CNL-19-069

Watts Bar Nuclear Plant, Units 1 and 2
Facility Operating License Nos. NPF-90 and NPF-96
NRC Docket Nos. 50-390 and 50-391

SUBJECT: Final Response to NRC Request for Additional Information Regarding Watts Bar Nuclear Plant, Units 1 and 2, Application to Adopt 10 CFR 50.69, "Risk-informed Categorization and Treatment of Structures, Systems, and Components for Nuclear Power Reactors" (WBN-TS-17-24) (EPID L-2018-LLA-0493)

Figure 5-6 (from NEI 00-04)
Other External Hazards

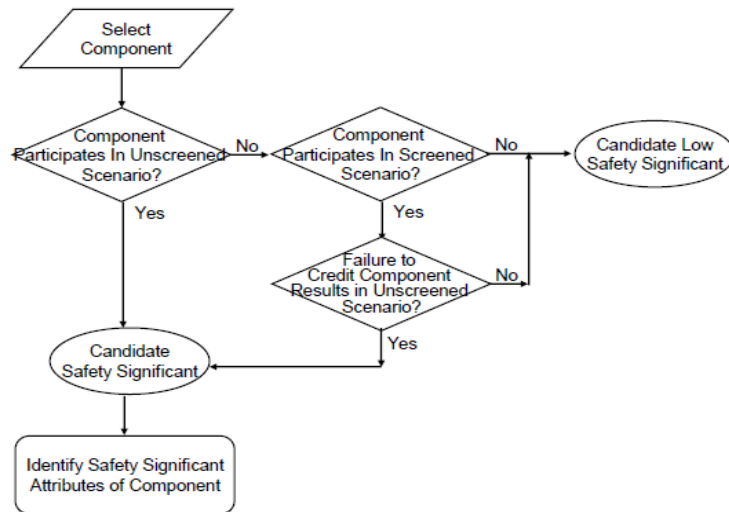
- iii. *If the external flooding hazard is screened out, identify any active and passive SSCs that are credited for the screening (i.e. credited as flood protection features) and discuss how those SSCs will be included and considered in the proposed categorization process.*
- b. *Attachment 4, "External Hazards Screening," of the LAR screens extreme wind and tornado hazards. The discussion of the screening criteria is based on the design of Category I structures as well as the design and protection against tornado and tornado missile hazards. It is unclear if any SSCs are being credited as part of the screening (i.e. protection features) of the high winds and tornado, including tornado missile, hazard and how any such SSCs will be considered in the categorization process.*

Active and passive SSCs that are required to mitigate the consequence of external flooding consist of doors, manhole covers, sumps, walls, floors, and ceilings (hence, watertight seals for penetrations).

The process to follow for the above components credited for External Flood mitigation are described by Figure 5-6 “Other External Hazards” from NEI 00-04. As noted in Reference 4, TVA will follow the requirements of the endorsed guidance. Therefore, TVA is subjecting the external hazards (excluding internal fires and seismic hazards) to the process described by the following flow chart in NEI 00-04, Figure 5-6. As part of the categorization assessment of “other external hazard” risk, an evaluation is performed to determine if there are components being categorized that participate in screened scenarios and whose failure would result in an unscreened scenario. Those components would be classified as high safety significant (HSS).
